**Committee of Experts on the Transport of Dangerous Goods
and on the Globally Harmonized System of Classification
and Labelling of Chemicals****Sub-Committee of Experts on the Transport of Dangerous Goods****Forty-fifth session**

Transport of gases: miscellaneous**Packing instructions P200 and P206 for collective entries****Transmitted by the expert from Germany¹****Introduction**

Fig. 1: Schematic presentation of the volumetric expansion for the calculation of the internal pressure in pressure receptacles containing liquid phases and compressed gas

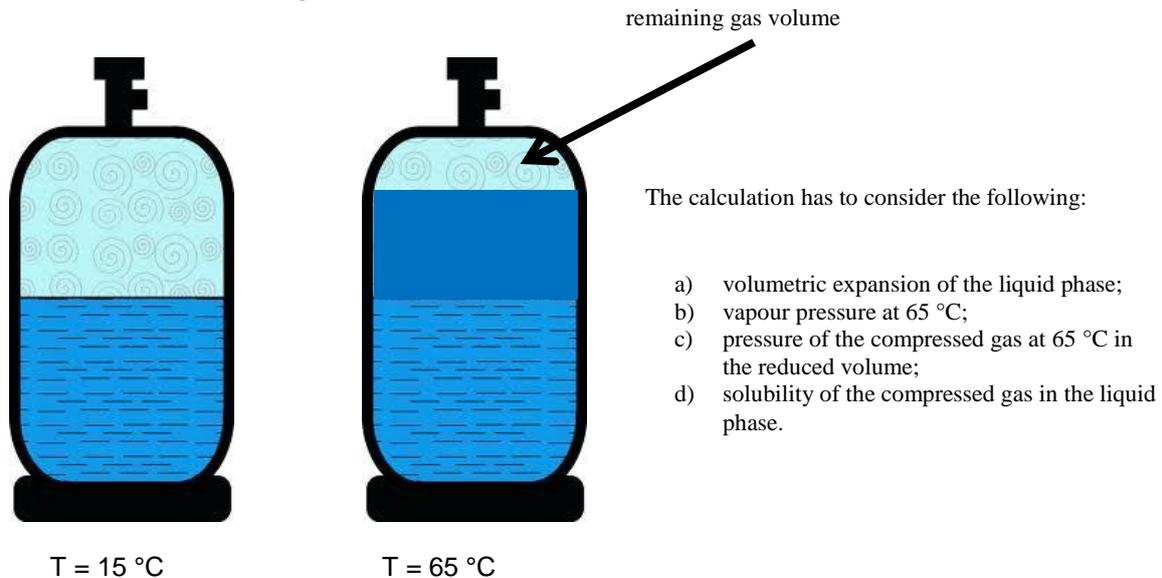
4. For cases where a liquid phase of a fluid is charged with a compressed gas, the above packing instructions do not include instructions on how to calculate the filling ratio and test pressure. In these cases, both components – the liquid phase and the compressed gas – have to be taken into consideration in the calculation of the internal pressure in the pressure receptacle.

This is shown in Figure 1:

5. If only the compressed gas is considered in accordance with P200 (3) (a), this results in calculated pressures which are too low and not acceptable from the point of view of safety. If only the vapour pressure of the liquefied component at 65 °C is considered in accordance with P200 (3) (c) and/or P206 (3), this also result in calculated pressures which are too low and not acceptable from the point of view of safety.

“(e) For liquefied gases charged with compressed gases, both components – the liquid phase and the compressed gas – have to be taken into consideration in the calculation of the internal pressure in the pressure receptacle.

When filled, the internal pressure at 65 °C shall not exceed the test pressure of the pressure receptacles. The vapour pressures and volumetric expansions of all substances in the pressure receptacles shall be considered. When experimental data is not available, the following steps shall be carried out:
